RESOLUTION R-5724

A RESOLUTION OF THE CITY OF KIRKLAND APPROVING THE ISSUANCE OF A PROCESS IIB PERMIT FOR AN AMENDED MASTER PLAN (DEVELOPMENT PLAN), AS APPLIED FOR IN THE PLANNING AND BUILDING DEPARTMENT FILE NO. ZON25-00491, EMERSON CAMPUS MASTER PLAN AMENDMENT, AND SETTING FORTH CONDITIONS TO WHICH SUCH PERMIT SHALL BE SUBJECT.

**Emerson Campus Master Plan Amendment
Process IIB Review, ZON25-00491**

File: Emerson Campus Master Plan ¹ (Development Plan) Amendment, ZON25-00491

AVE. GRADE - WEST ELEVATION

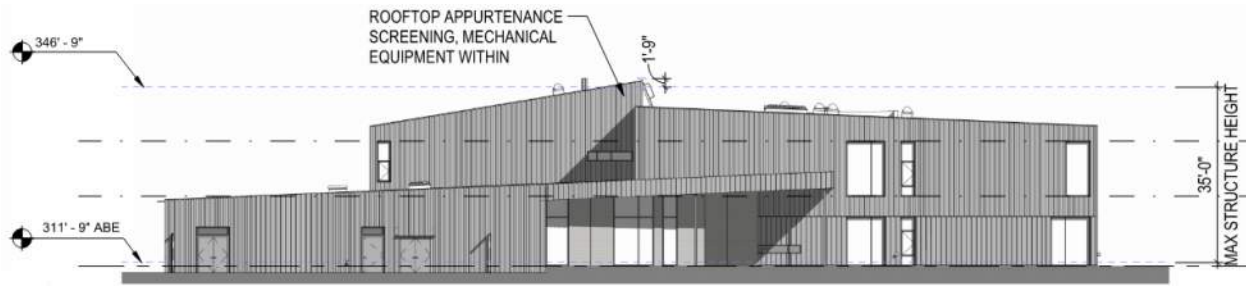
<p>c. The increased height is not specifically inconsistent with the applicable neighborhood plan provisions of the Comprehensive Plan; and</p>	<p>The increased height is not prohibited by the Comprehensive Plan.</p>
<p>d. The increased height will not result in a structure that is incompatible with surrounding uses or improvements.</p>	<p>The building is set back more than 200' from the west and north property line and buffered from east and south neighbors by mature trees, reducing visual impact of a height increase.</p>

The proposed structure is less than 35 feet maximum height (less rooftop appurtenance).

BASIS OF BEARINGS

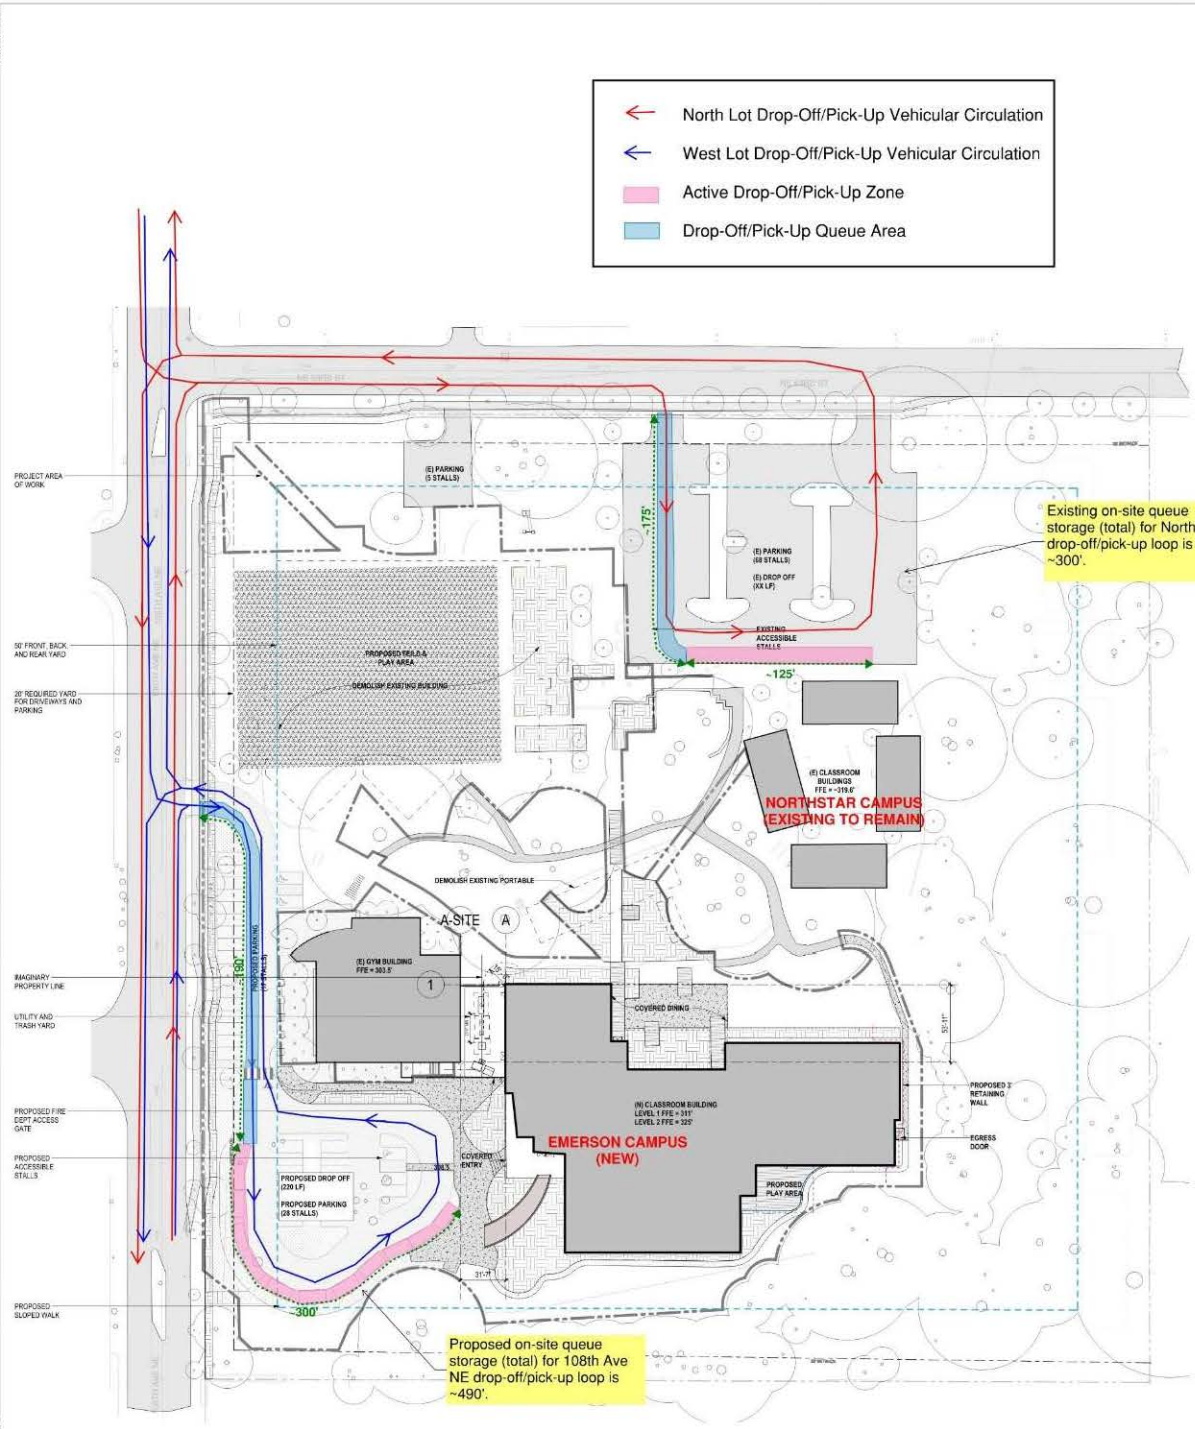
PREPARED FOR
**LAKE WASHINGTON
SCHOOL DISTRICT**

BEGINNING AT THE NORTHWEST CORNER OF LOT 1, BLOCK 3, KIRKLAND PARK, ACCORDING TO THE PLAT THEREOF RECORDED IN VOLUME 6 OF PLATS, PAGE 28, IN KING COUNTY, WASHINGTON; THENCE SOUTH ALONG THE EAST MARGIN OF 108TH AVENUE NORTHEAST, 670 FEET; THENCE SOUTH 89°47'00" EAST, 655 FEET; THENCE NORTH PARALLEL WITH THE EAST LINE OF 108TH AVENUE NORTHEAST FOR 670 FEET TO THE SOUTH LINE OF NORTHEAST 53RD STREET; THENCE WEST ALONG SAID SOUTH LINE, 655 FEET TO THE TRUE POINT OF BEGINNING;
